From: Katelyn E. Sullivan
Sent: December 17, 2019 12:02 PM
To: Dianne Boisvert
Subject: FW: [Ext]10 Mullikan Way
Attachments: 19-120 SP-SP 12-16-19.pdf; 10 Milliken Kennel sand trench detail - REV BY ENG 12-17-19.pdf

PROJECT NAME
10 MULLIKEN WAY
NEWBURYPORT, MA

SITE PLAN

2 MULTI FIBER TURF DETAIL & TREATMENT TRENCH
NOT TO SCALE

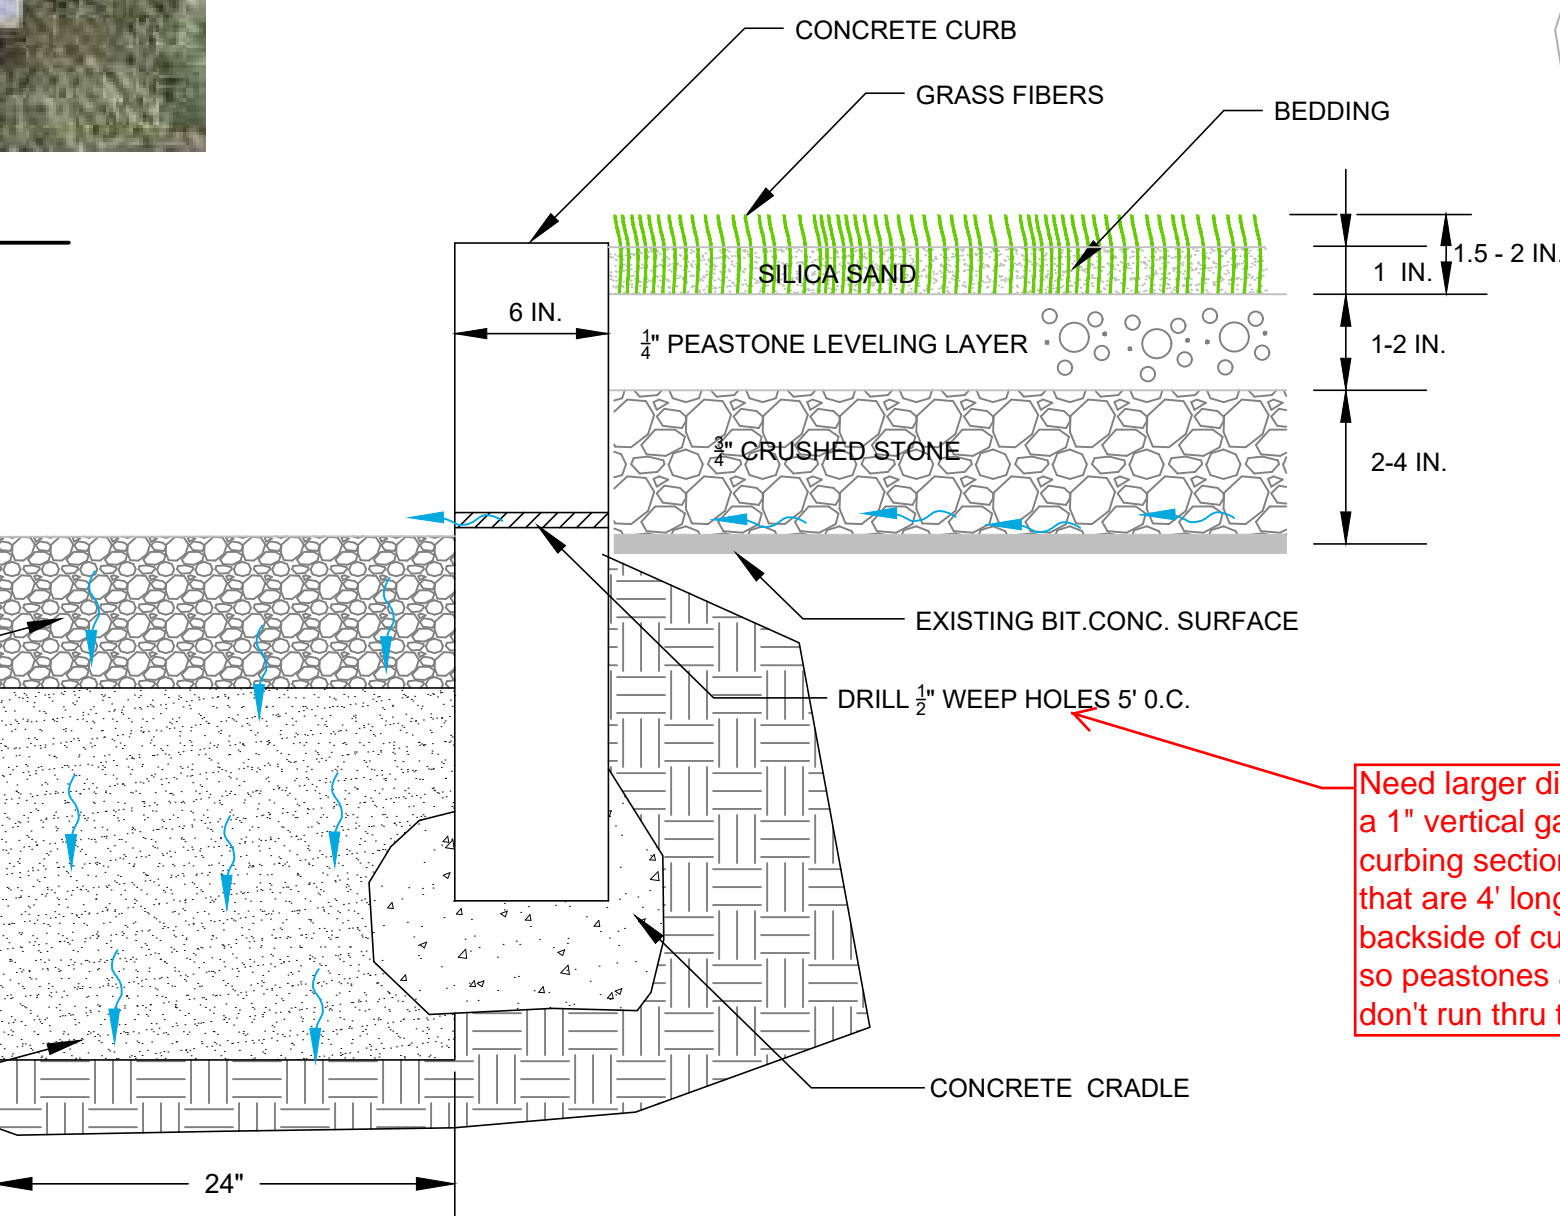
- The most logical BMP that I feel should work is as shown on the attached trench.

2. This sand trench will behave similar to a typical homeowner's septic system leaching field (similar, not exact) in that it is porous sand that provides some air to allow the natural breakdowns of the bacteria. I am not saying that a bio-mat will form as they do in leaching fields but this trench will provide some level of treatment.

3. The kennel owners MUST remove the feces asap so the trench does not get overloaded. Hosing it down will allow it to drain through the turf, into the sand layer below, and across the asphalt into the sand trench for final treatment. Rainfall will do the same.

Need larger diameter, 2" min OR leave a 1" vertical gap between granite curbing sections. Use curb sections that are 4' long and put fabric against backside of curbing to cover the gaps so peastones and crushed stones don't run thru them.

Based upon our discussion last Friday concerning your review we have updated the turf detail to treat the runoff running out from under the turf surface to the edge of the pavement under the turf surface. We have provided a 2' wide treatment trench to treat this runoff. See the updated plan with this detail.
